UNITED STATES PATENT AND TRADEMARK OFFICE

APPLICATION NO.	FILING DATE	FIRST NAMED INVENTOR	ATTORNEY DOCKET NO.	CONFIRMATION NO.
09/988,864	11/19/2001	Jacques Agostini	33900-91	9200

**Office Action Summary**

## DETAILED ACTION

FIG. 2

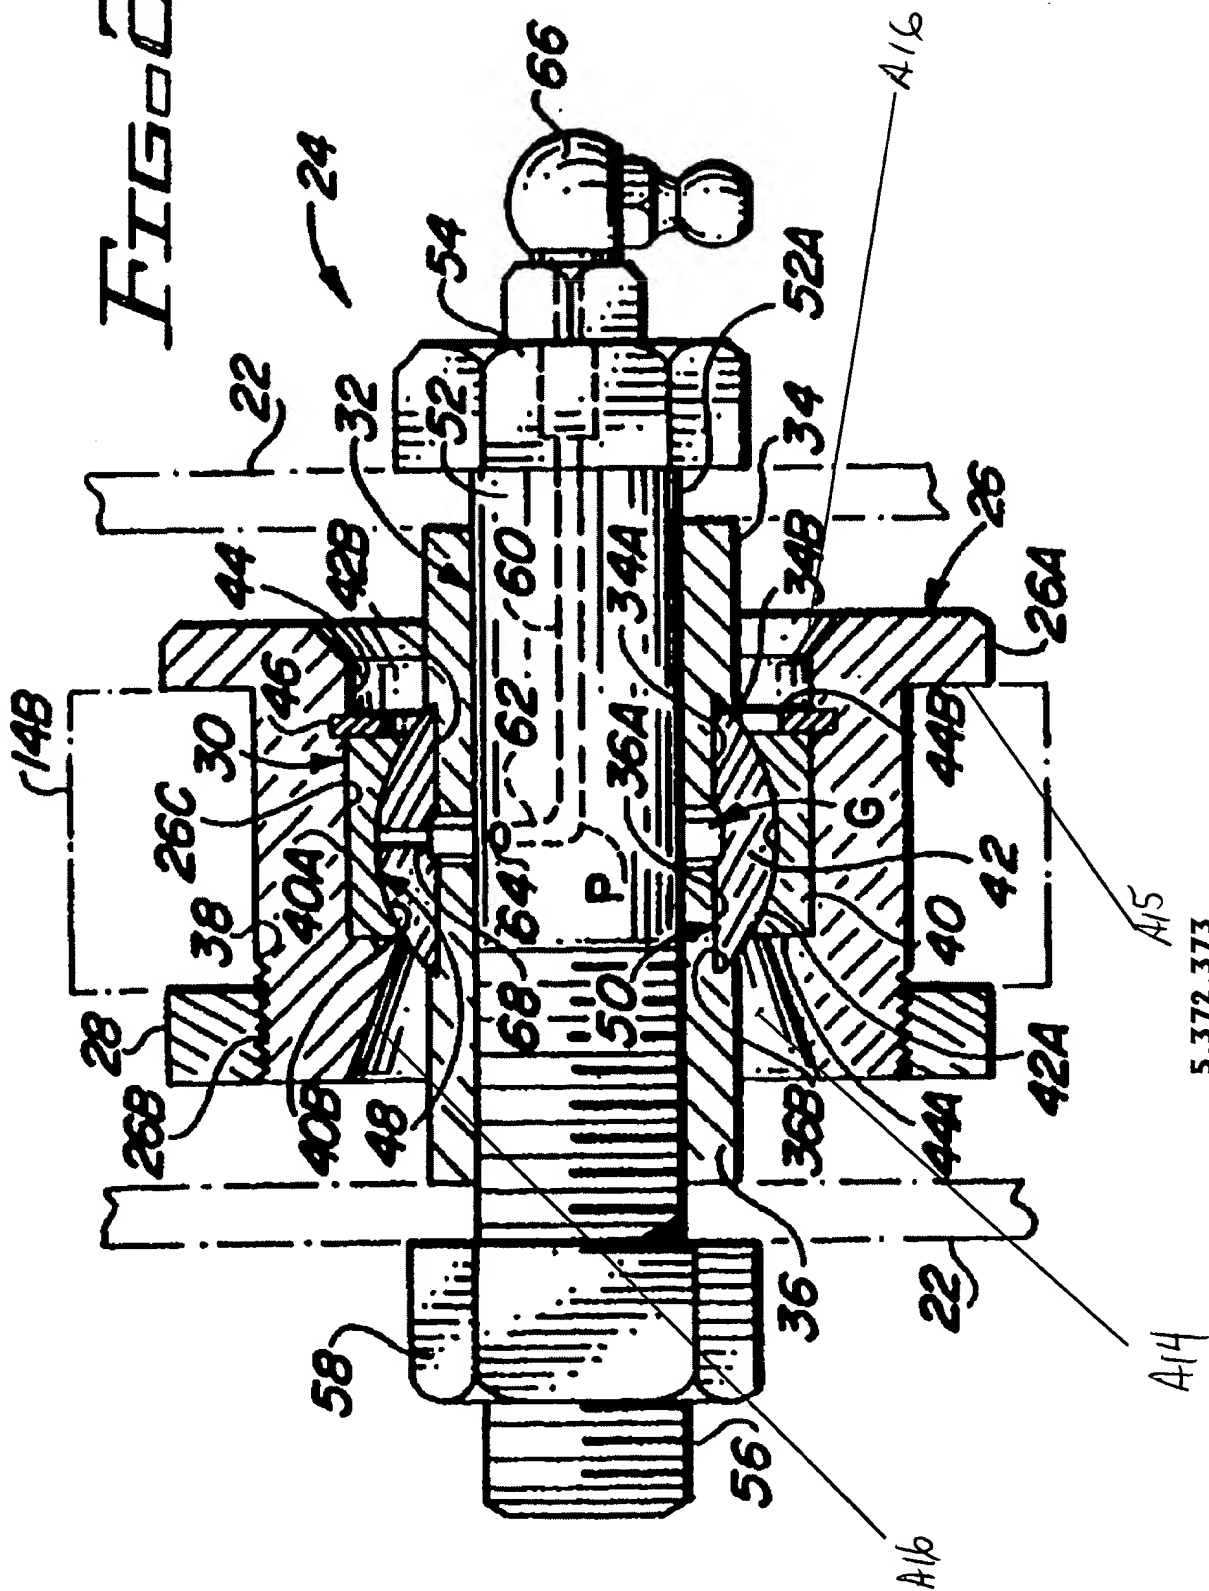
Claims 1-4 and 6-8 are rejected under 35 U.S.C. 102(b) as being anticipated by Reel, 5,372,373 (see marked-up copy).

Regarding claim 1, Reel discloses in Fig. 2 a joint comprising a nut **26**, a ring **42**, and a lock-nut **28**. The nut **26** is provided with an axial cavity **44** presenting spherical walls **40B** opening out in a divergent bore **A4** made inside a threaded sleeve **26B** extending from the nut **26**. The ring **42** comprises a portion of a ball **42** having a spherical wall **42B**.

Regarding claim 3, the ring **42** is tapped. Furthermore applicant is reminded that a recitation with respect to the manner in which a claimed apparatus is intended to be employed does not differentiate the claimed apparatus from a prior art apparatus satisfying the claimed structural limitations. *Ex parte Masham*, 2 USPQ2d 1647 (1987).3.

Regarding 4, the ring **42** comprises a throat **68**.

Regarding claim 7, the nut **26** comprises an annular shoulder **26A** defining a face **A15**.

Regarding claim 8, respective outer lateral edges **A16** of the cavity **44** and of the bore **A4** are beveled.

**FIG. 2**  
PRIOR ART

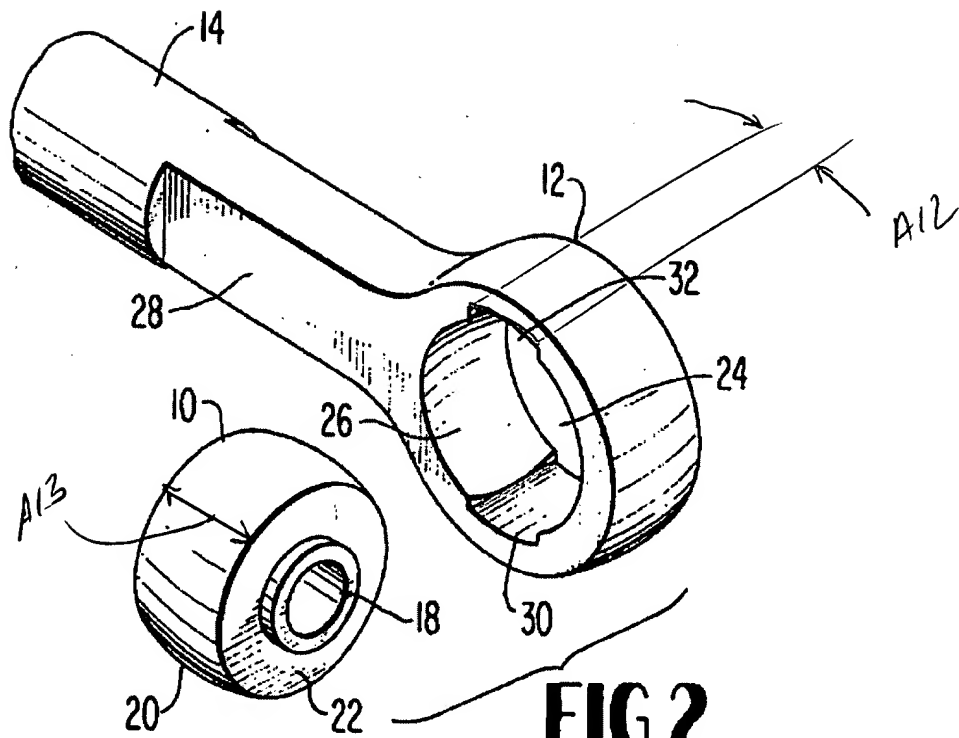
Claim 5 is rejected under 35 U.S.C. 103(a) as being unpatentable over Reel, 5,372,373, in view of Duncan, 3,941,495 (see marked-up copy).

Regarding claim 5, Reel, as discussed above, fails to disclose the cavity **44** comprises two diametrically opposite lateral notches; and each of the notches has a angular length slightly greater than a width of the ring **42**. Duncan teaches in Figure 2, as prior art, a cavity **24** comprising two diametrically opposite lateral notches **30, 32**; and, each of the notches **30, 32** has a angular length **A12** slightly greater than a width **A13** of the ring **42** to facilitate insertion of a ring into the cavity (col. 1, lines 28-34). Therefore, as taught by Duncan, it would have been obvious to one of ordinary skill in the art at the time the invention was made to include two diametrically opposite lateral notches each having an angular length slightly greater than the width of the ring of Reel to facilitate insertion of the ring into the cavity.
